Addendum 89 – Regulation No. 90

Revision 3 - Amendment 3

Supplement 3 to the 02 series of amendments – Date of entry into force: 9 February 2017

Uniform provisions concerning the approval of replacement brake lining assemblies, drum-brake linings and discs and drums for power-driven vehicles and their trailers

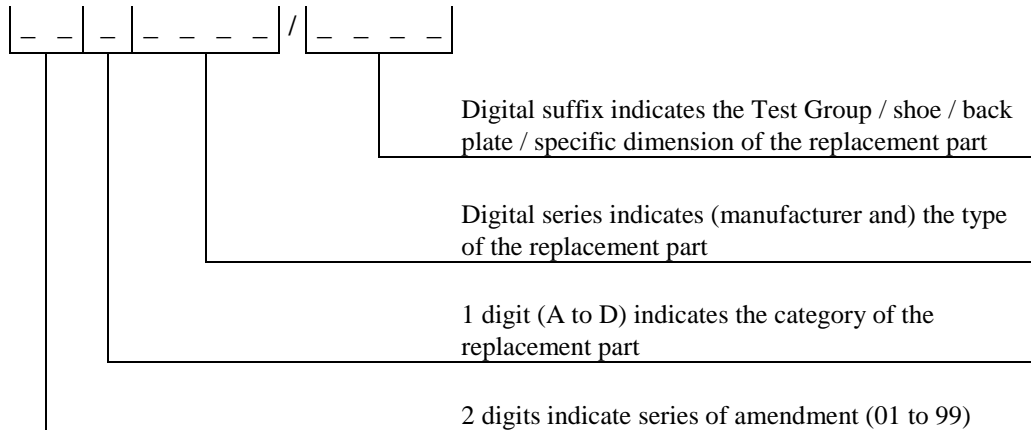
Paragraph 4.2.3., amend to read:

"4.2.3. The next series of digits shall indicate the manufacture and the type of the brake lining, the type of disc or the type of drum.

The digital suffix shall indicate:

- (a) The shoe or back plate or specific dimension in the case of drum brake linings;
- (b) The Test Group in the case of a replacement disc or replacement drum.

Add a new paragraph 3., to read:

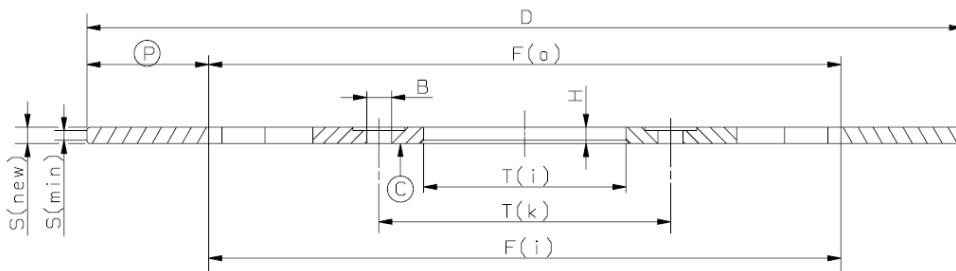
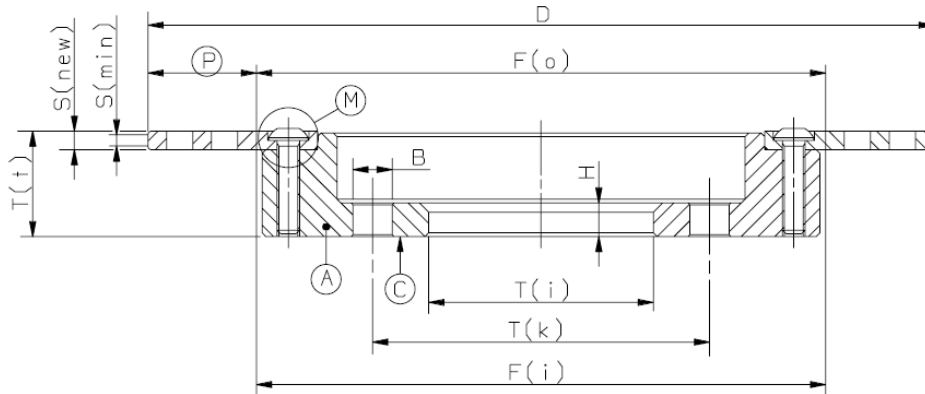
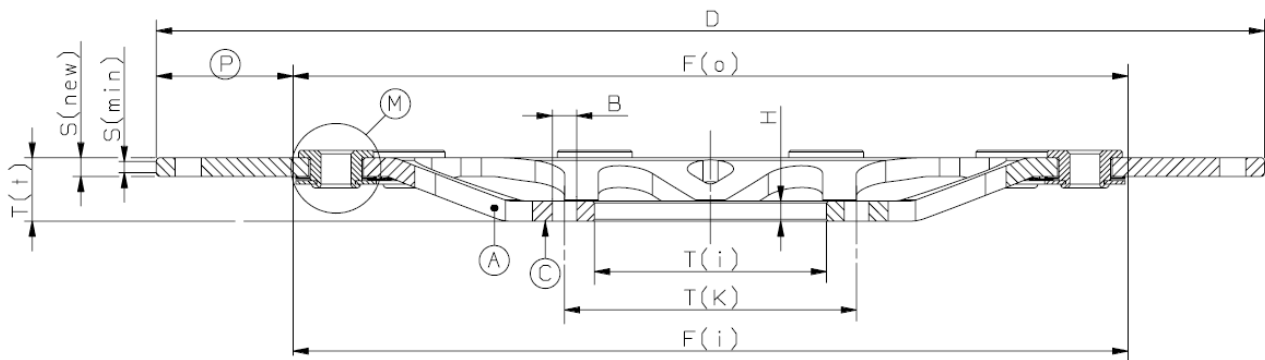
- "3. Brake disc design types for L₁, L₂, L₃, L₄ and L₅ categories (examples)
 One-piece type: brake disc with braking surface and bell made in a single piece and, therefore, of the same material

Composed fixed type: brake disc having the braking ring made of steel, while the bell is of other material, generally aluminium; the 2 components are rigidly bounded by a screwed or riveted connection.

Floating type: brake disc having the braking ring radially released from the bell, in order to allow its thermal expansion.

Figure 1

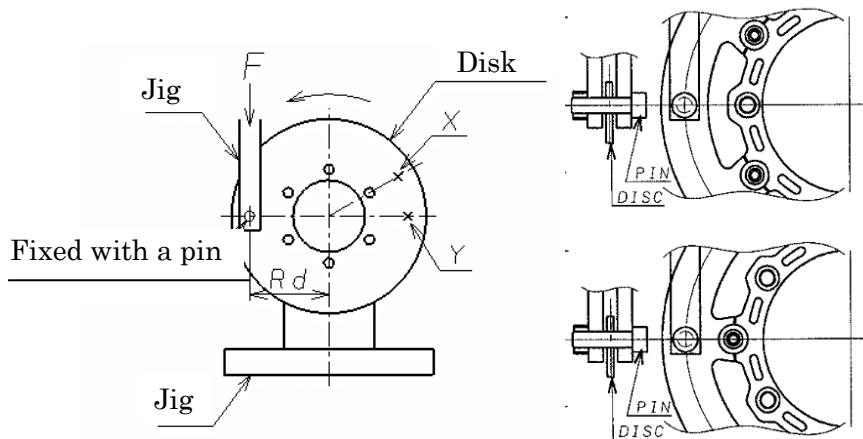
2.2. Test procedure and conditions

Static test performed on special test bench shown in Figure 1.

- 2.2.1. Drill a hole on the braking surface of the disc at a distance from the centre equal to the effective radius R_d .
- 2.2.2. Position the disc on the test bench and fasten it using specific fastening screws.
- 2.2.3. Connect the bench arm to the hole drilled on the brake disc.
- 2.2.4. Apply the force F , specified in Table A14/2.2.5., as shown in Figure 1.
- 2.2.5. Record strokes and forces as shown in Figure 2.

Figure 2
Movement

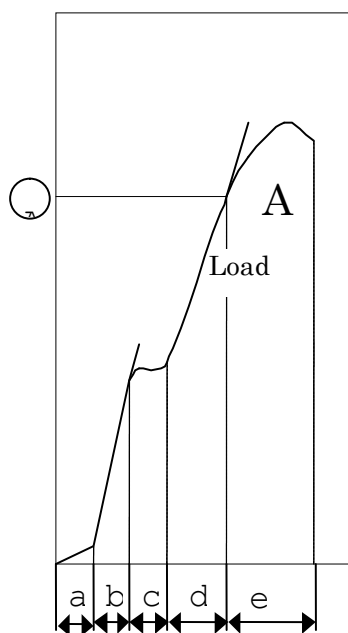
- (a) Adjustment stroke of the equipment (recovery of any clearance between the hole on the braking surface and the connection pin to the bench arm);
 - (b) Load developed by the fastening screws to the equipment;
 - (c) Movement of the brake disc caused by its rotation with sliding on the plate of the equipment, when the disc's fastening screws bear against the fixing holes of the disc;
 - (d) Load supported by the brake disc;
 - (e) Permanent deformation of the brake disc (starting from point A).
- 2.3. Test results

The disc shall not permanent deformations before reaching the force F specified in Table A14/2.2.5; the measurement of the deformation force must be performed at point A as in Figure 2.

Figure 3

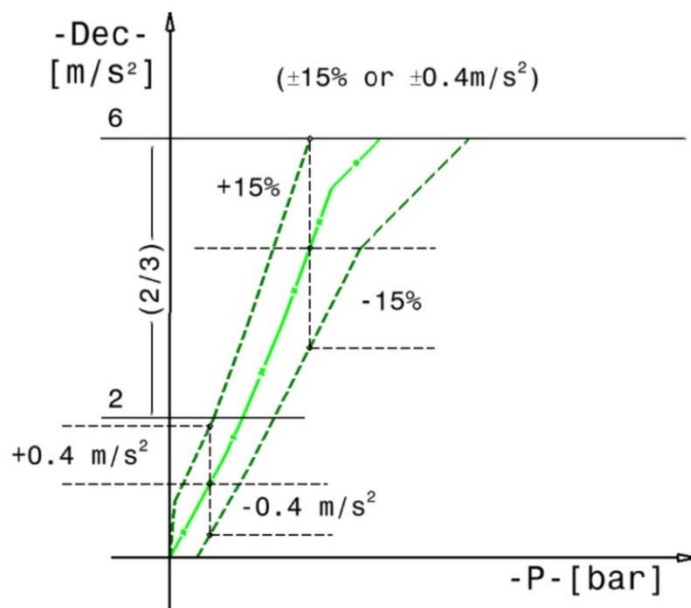
3.2.6.4. The dynamic frictional properties of the replacement brake disc can be regarded as similar to those of the original brake disc, provided the values attained in relation to the mean fully developed deceleration at the same operating pressures or control forces in the region of the upper 2/3 of the curve generated do not deviate by either ± 15 per cent or $\pm 0.4 \text{ m/s}^2$ from those of the original brake disc (see an example of the curve in Figures 3 and 4).

Figure 1

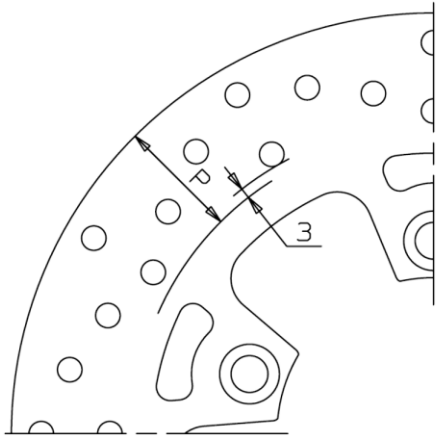
- 1.1. Case of braking surface with lightening (holes, slots, wave, etc.) on the braking surface (Figure 1) only: 3 mm towards the centre of the disc from the end of the lightening.

Figure 2

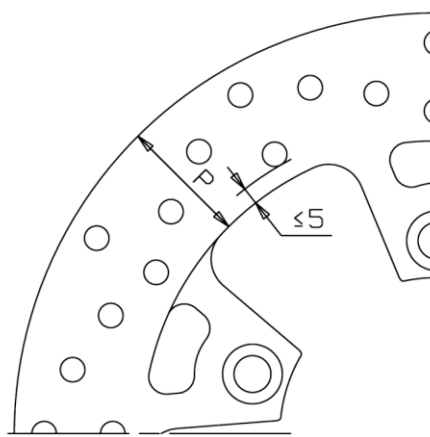
- 1.2. Case of braking surface with lightening (holes, slots, wave, etc.) with distance from the disc's internal diameter lower than 5 mm (Figure 2): diameter of the brake disc undercut.

Figure 3

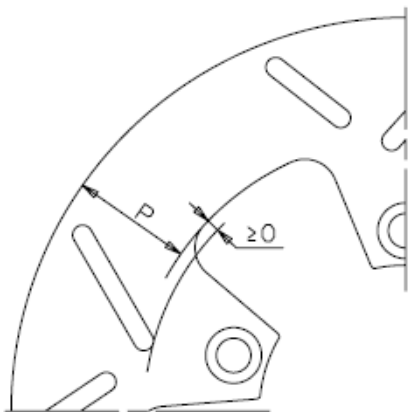
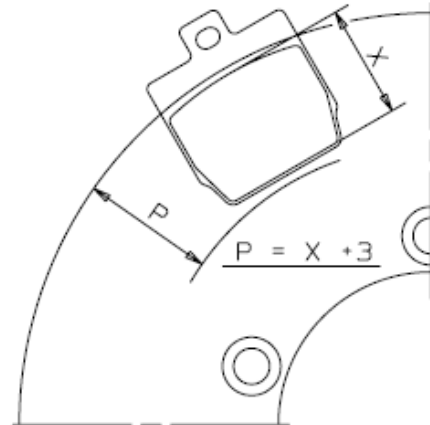
- 1.3. Case of braking surface with lightening (holes, slots, wave, etc.) which terminate inside, outside the brake disc undercut (Figure 3): diameter of the brake disc internal undercut.

Figure 4

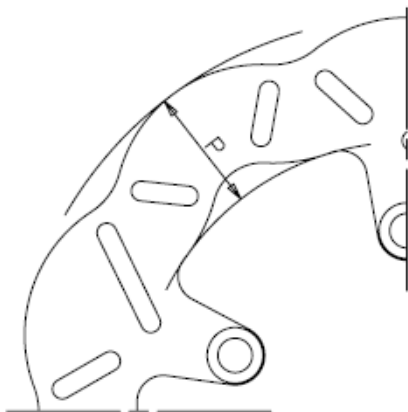
- 1.4. All other cases: internal diameter defined by the radial width of the largest combinable pad, to which 3 mm need to be added (Figure 4).
